Answer for the ACEA Comments on the current
development stage of Flex-PLI, Sep. 2007

Relationship between the Knee Bending Angle and Knee MCL Elongation of Human Model

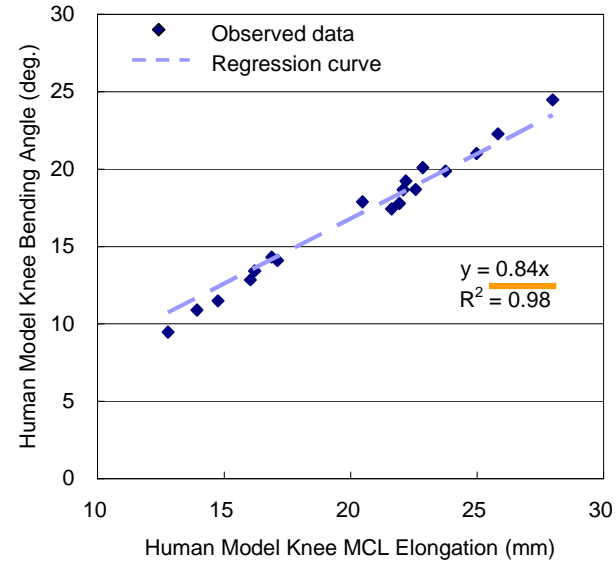
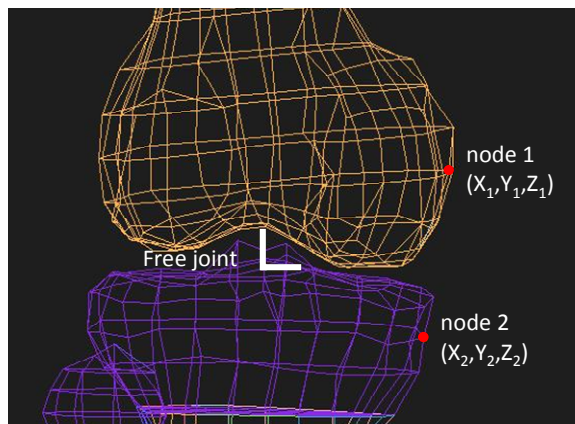
- Regarding the criteria for the bending angle the correlation (transfer function) between bending angle and ligament elongation (MCL) should be illustrated in an extra TEG paper (see table "tentative threshold" of TEG/22/). This would close the gap between the 50%-injury-risk level for bending angle and the actually measured ligament elongation value

- The illustration of the transfer function (bending angle to MCL elongation) is needed.

- We described the relationship between the bending angle and MCL of the human model in the next page (Page 9).
- We used the relationship.

$$HM_{MCL} = (0.83 \text{ or } 0.84) \times HM_{KBA}$$

} Ans.
• Answered in the Page 9.
